**Southern Nuclear Operating Company
Vogtle Electric Generating Plant Units 3 and 4
Request for License Amendment:
Technical Specification Changes to Support Operability During Mode 5
Vacuum Fill Operations (LAR-18-009)**

**Technical Specification Changes to Support Operability During Mode 5
Vacuum Fill Operations**

(LAR-18-009)

Figure 1: Depiction of PRHR HX Inlet Line (Not to Scale)

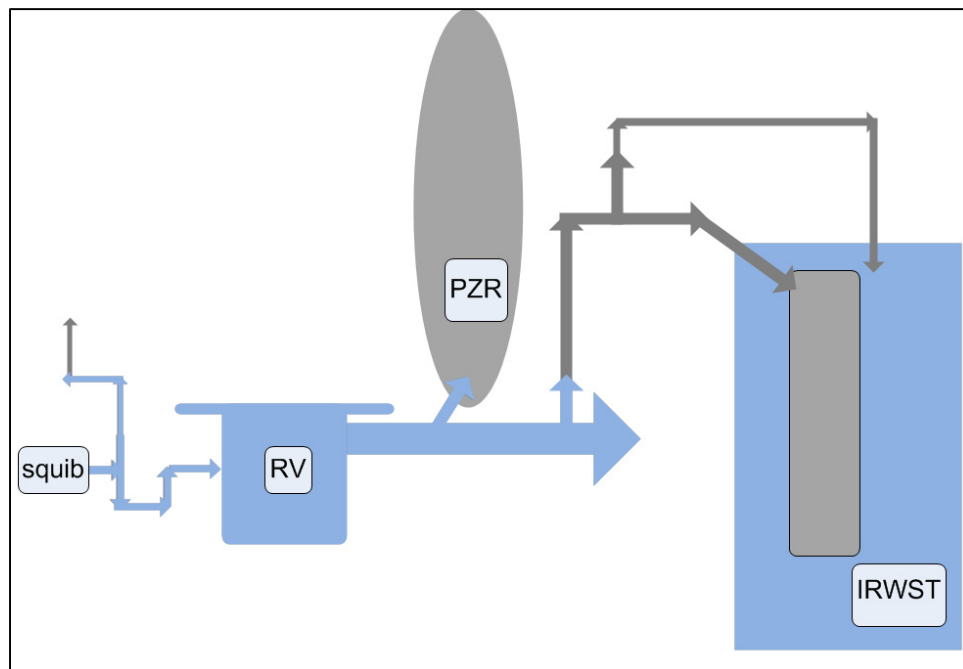
During RCS vacuum fill, the PRHR HX inlet line begins to fill along with the RCS. When pressurizer level reaches 20%, TS 3.5.5 requires the PRHR HX to be OPERABLE. However as shown in Table 1 and Figure 1, a pressurizer level of 20% is below the elevation of the high point water level sensor in the PRHR HX inlet line. As such, at that time the inlet line cannot be vented. Therefore, the PRHR HX inlet line noncondensable gas volume is out of limit, making

the PRHR HX inoperable due to failure of SR 3.5.4.3 (which is required per SR 3.5.5.1). When the RCS is water solid and returned to atmospheric conditions prior to concluding vacuum refill operations, the PRHR HX will be vented and restored to OPERABLE status.

Therefore, TS 3.5.5 SR 3.5.5.1 imposing the requirement to meet SR 3.5.4.3 unnecessarily precludes compliance with TS 3.5.5 once the RCS reaches 20% pressurizer level during vacuum refill. As such, SR 3.5.5.1 is proposed to be revised to account for RCS vacuum fill operations.

Changes to COL Appendix A (Plant-specific Technical Specification) TS 3.5.5 are proposed to add a Note to the Applicability which states "PRHR HX is not required to be OPERABLE in MODE 5 during RCS vacuum fill operations." In addition, UFSAR Subsection 19E.2.3.2.4 is revised to note that the PRHR HX does not provide decay heat removal during RCS vacuum fill operations. With these changes, the PRHR HX is not required to be OPERABLE during RCS vacuum fill.

- LCO 3.5.5 Applicability is revised to add a note "PRHR HX is not required to be OPERABLE in MODE 5 during RCS vacuum fill operations."

Figure 2: Depiction of IRWST Injection Line (Not to Scale)

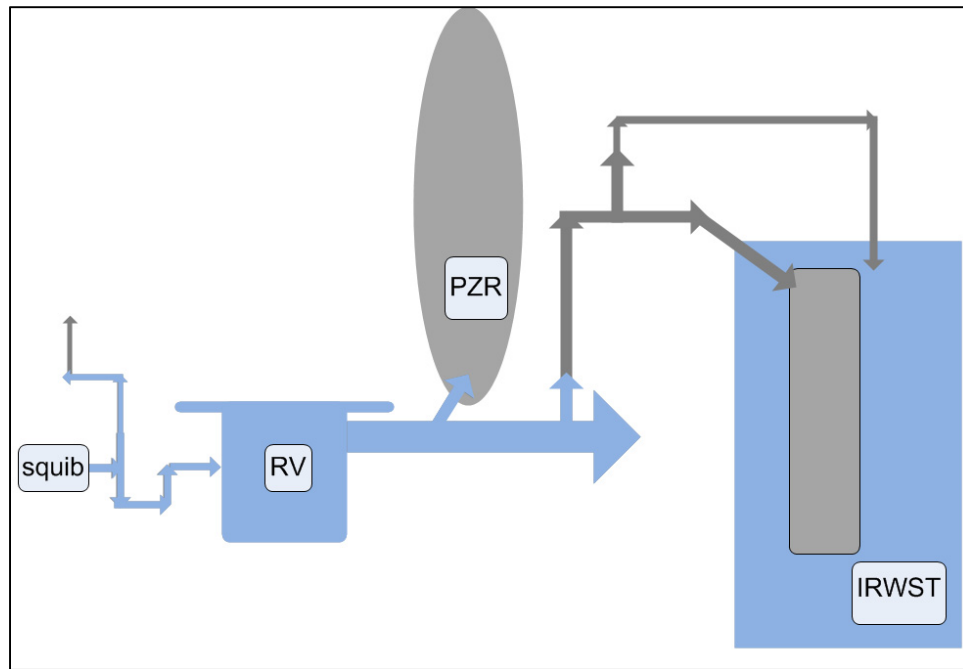
When vacuum refill conditions are established in MODE 5, the RCS level is at mid-loop, and the pressure at the high point level sensors may be less than the saturation pressure of expected RCS temperatures. As a result, the water in the IRWST injection high point vent lines will

vaporize the volume of water sufficiently to initiate an alarm which is primarily used to alert operators of noncondensable gas in the line (see Table 2 and Figure 2 for relative elevations). Therefore, the IRWST injection line noncondensable gas volume is out of limit, making the IRWST inoperable per failure of SR 3.5.6.3 (which is required per SR 3.5.7.1).

A gas void could form in the IRWST injection high point vent if dissolved gases were to come out of solution as pressure is reduced during vacuum refill. The size of the gas void is calculated to fill 53-63% of the IRWST injection high point vent piping depending on temperature. This will initiate an alarm; however, this volume would not penetrate into the main IRWST injection line and therefore would not interrupt IRWST injection flow. Therefore, the IRWST continues to be OPERABLE and meet its safety function.

Changes to COL Appendix A (Plant-specific Technical Specification) TS 3.5.7 are proposed to remove SR 3.5.6.3 applicability from SR 3.5.7.1 and add SR 3.5.6.3 applicability to new SR 3.5.7.2 with a Note that it is not required to be met during RCS vacuum fill operations.

- SR 3.5.7.1 is revised to invoke all SRs of TS 3.5.6, except SR 3.5.6.3.

- TS 3.5.7 is revised to add new SR 3.5.7.2 to invoke SR 3.5.6.3, with a Note that it is not required to be met during RCS vacuum fill.
